## **VERIFICATION REPORT**

Project Title	G2P Gornet (Gas to power)			
Project	Project OMV Petrom S.A., Upstream Romania, Asset VII Muntenia Est			
Proponent Str. Coralilor nr. 22, sector 1,				
	Bucureşti ("Petrom City")

Report Title	Verification of Upstream Emission Reduction for G2P Gornet project for the period 01.01.2022 – 31.12.2022
Report ID	21257974
Version	1.0
Date of Issue	22.06.2023
Prepared by	TÜV Rheinland Energy GmbH
Verification	
Body	
Contact	Am Grauen Stein, 51105 Cologne, Germany
	www.tuv.com/carbon
Approved by Denitsa.Gaydarova-Itrib@de.tuv.com (Technical Reviewer)	
Work carried	Florencia.Tamanini@de.tuv.com (Team Leader and Verifier)
out by Julius.Averkorn@de.tuv.com (Trainee)

Figure 2: Baseline scenario "flaring of associated gas" with boundary (source Doc. 12)

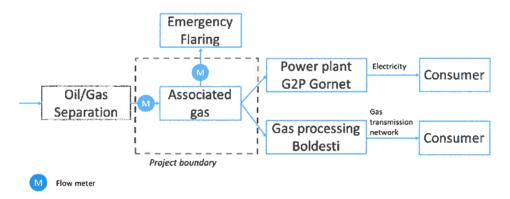
CAR/CL/FAR	Observation	Reference	Summary of project owner response	TÜV Comment
CAR2	Please adjust figure 2 & 3, so that the forwarding of the associated gas to Boldesti is included.	MR_G2P- Gornet_2022_v2_20 230525 - Chapter 2.1 & 2.2	The figures have been adjusted in MR v3, chapter 2.1	A corrected MR v3 has been submitted (Doc. 12). The current project scenario is correctly displayed within figure 2. The change has been positively verified.  CAR2 is closed.
CAR3	Please include that no flaring is happening at Boldesti site.	MR_G2P- Gornet_2022_v2_20 230525 - Chapter 2.3	Chapter 2.3 has been updated in MR v3	A corrected MR v3 has been submitted (Doc. 12). A small section that no gas will be flared at Boldesti facility site was added and positively verified.  CAR3 is closed.
CAR4	Please adjust paramter Fc <sub>y</sub> description to include volumes of recovered gas to Boldesti facility.	MR_G2P- Gornet_2022_v2_20 230525 - Chapter 4	This has been adjusted in MR v3. See also the response to CL 3	Adjustments have been positively verified while closing CL3.  CAR4 is closed.
